STATE OF CONNECTICUT
CONNECTICUT SITING COUNCIL

DOCKET NO. 436

RESPONSES OF MESSAGE CENTER MANAGEMENT AND NEW CINGULAR WIRELESS
TO CONNECTICUT SITING COUNCIL PRE-HEARING QUESTIONS, SET ONE

Attachment 7

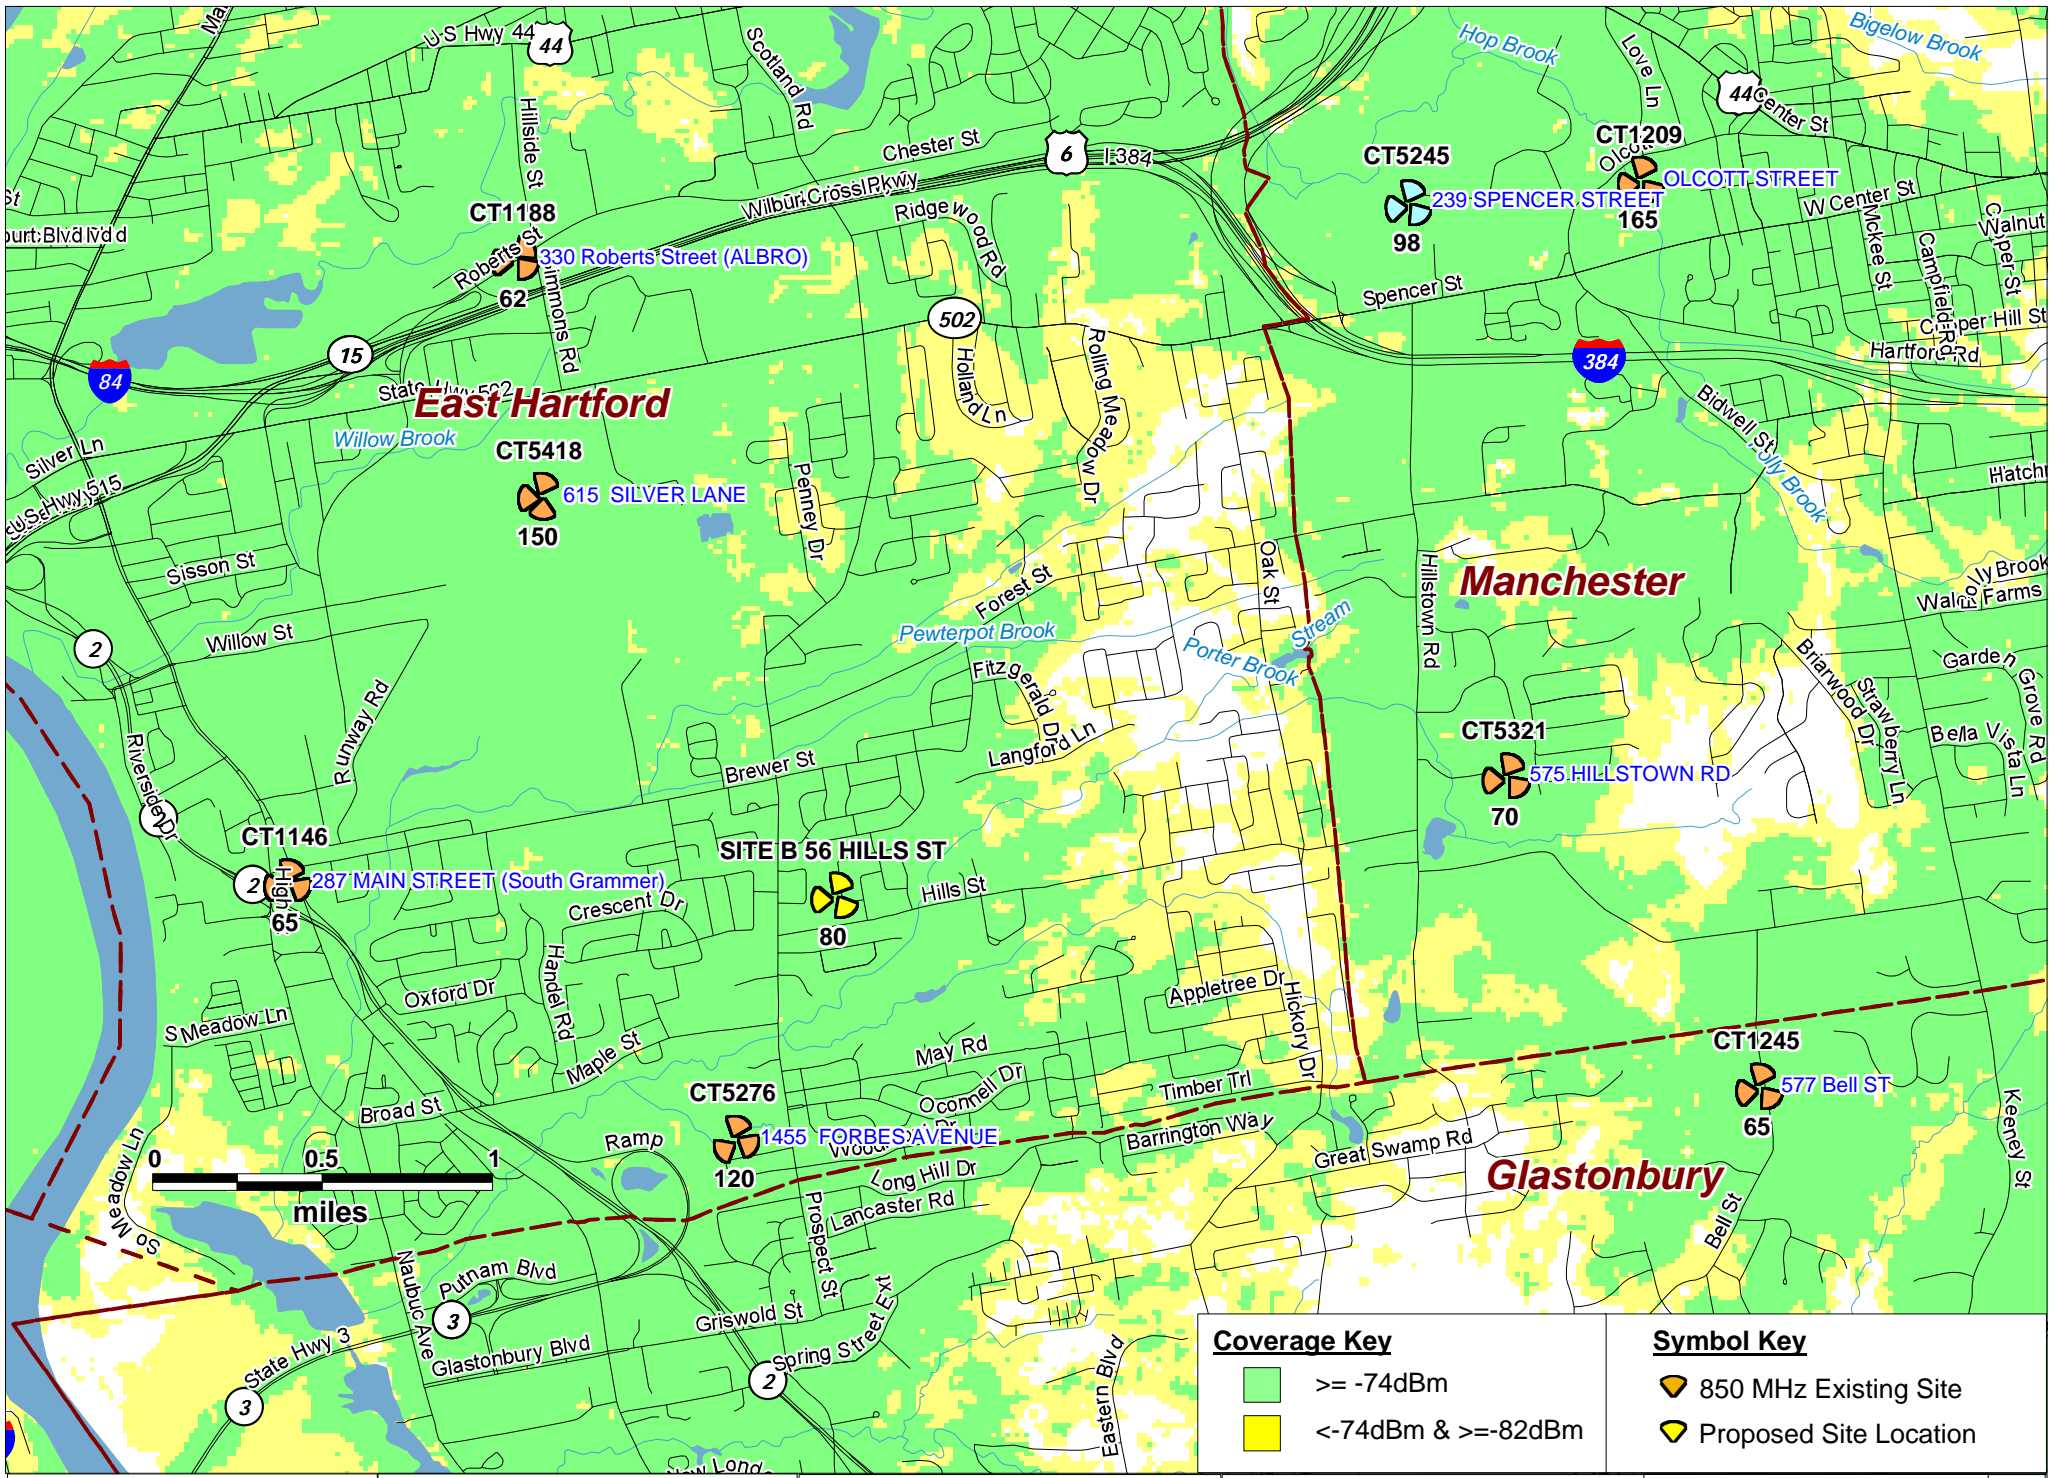
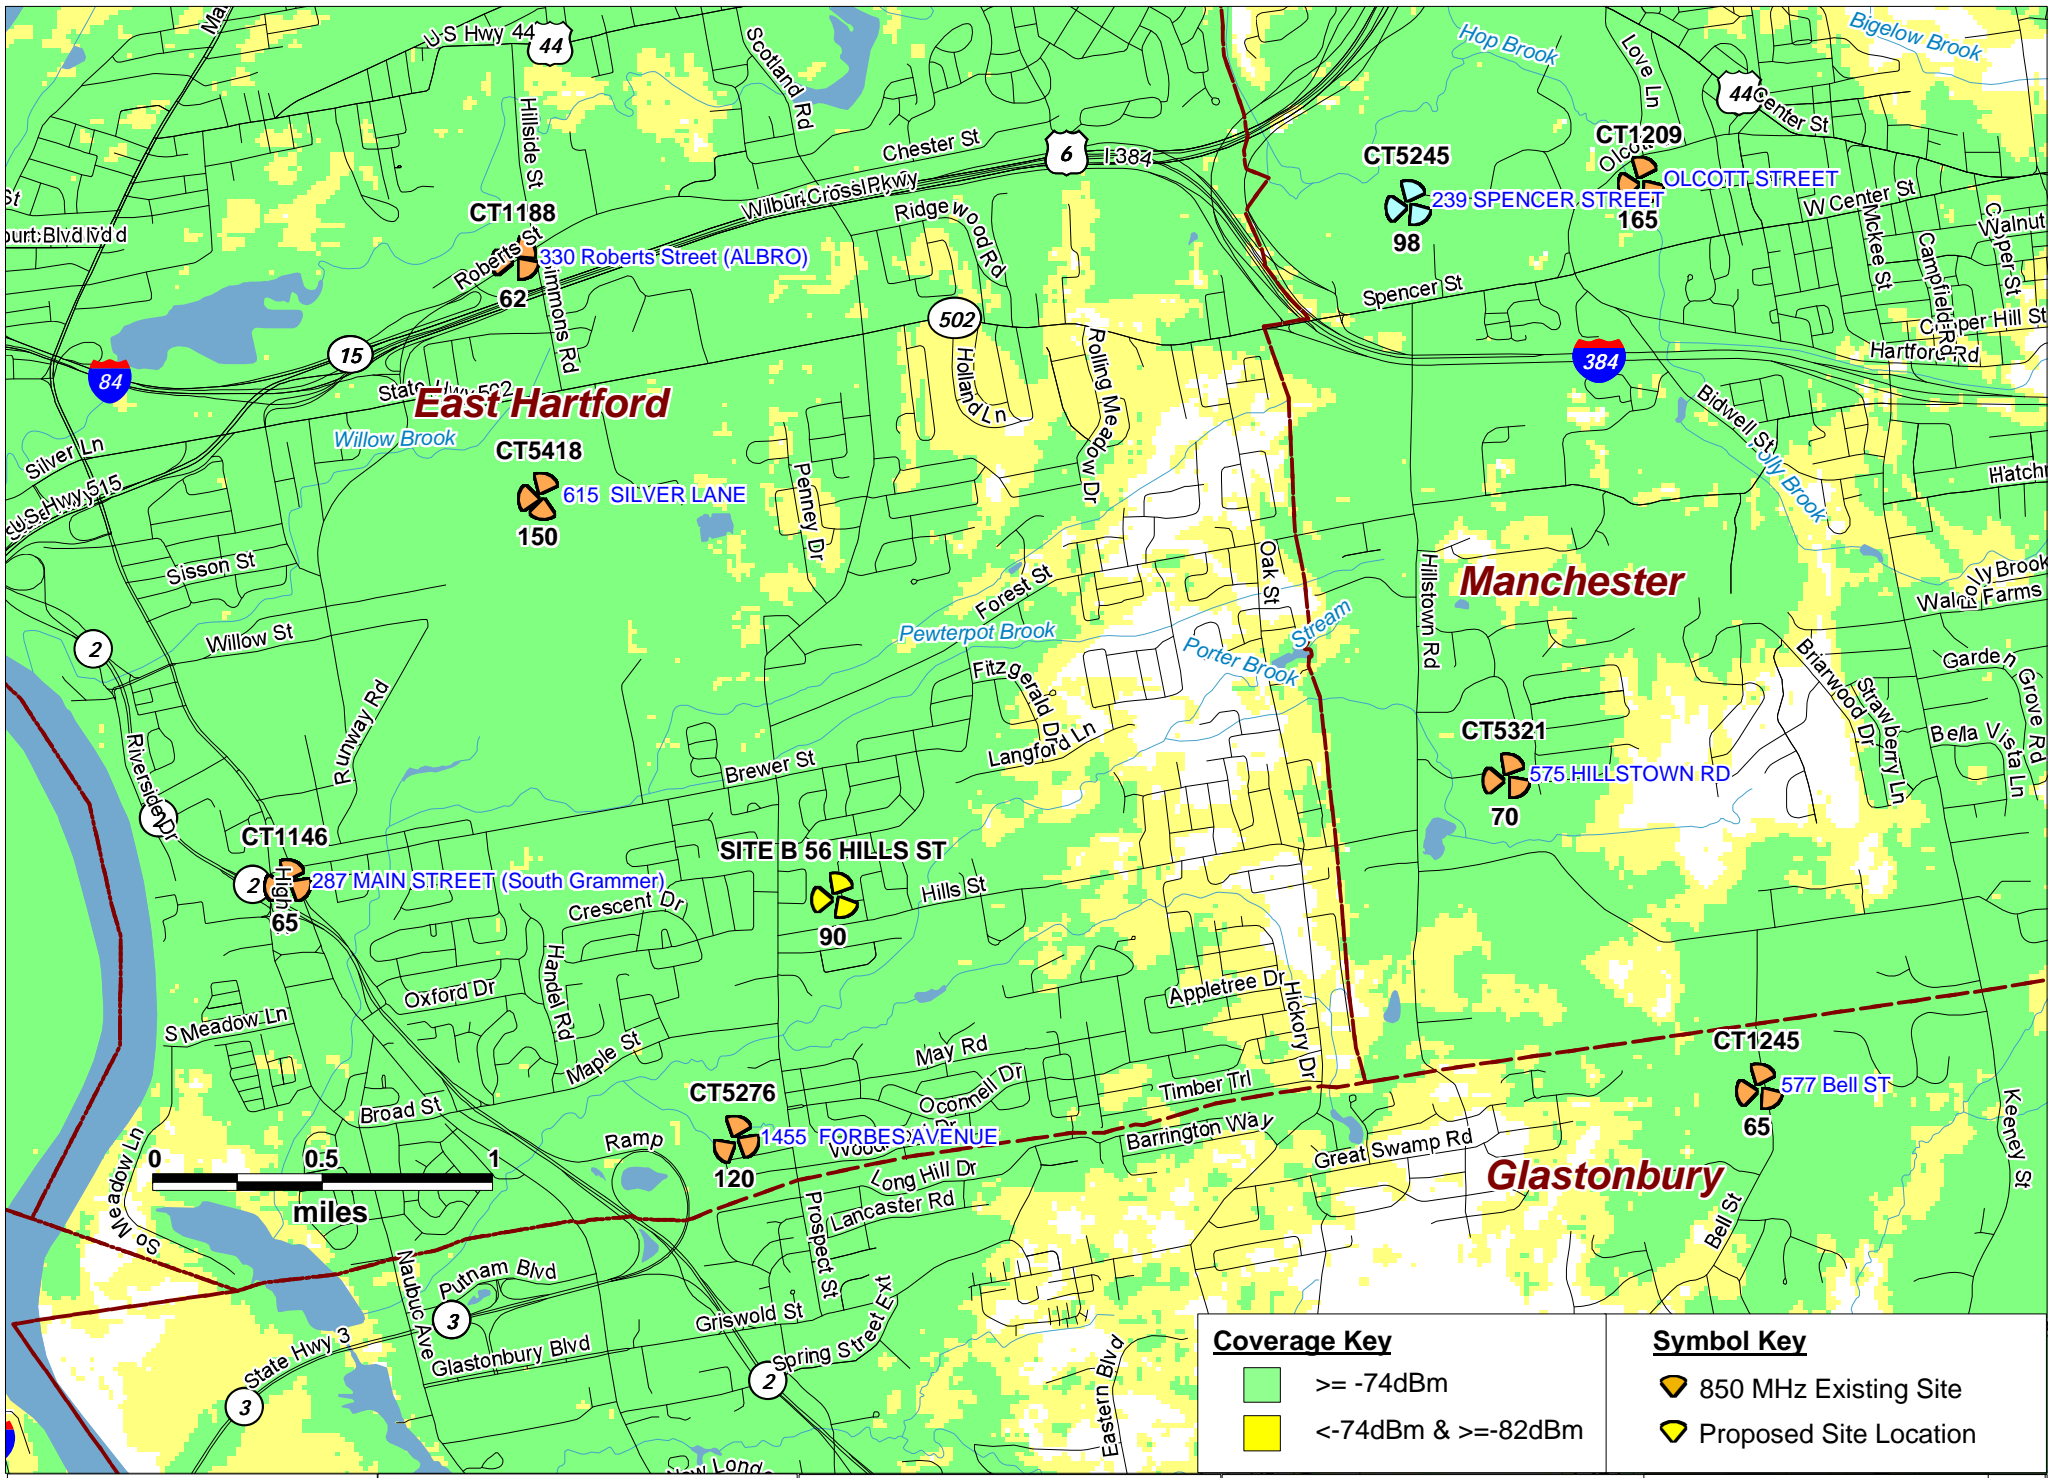
Q41. Using the same scale as the coverage plots in the Radio Frequency Analysis Report, provide separate coverage plots using the same scale provided in the Application assuming the Site B tower is ten and twenty feet shorter.

A41. *The requested plots are included as Attachment 7.*
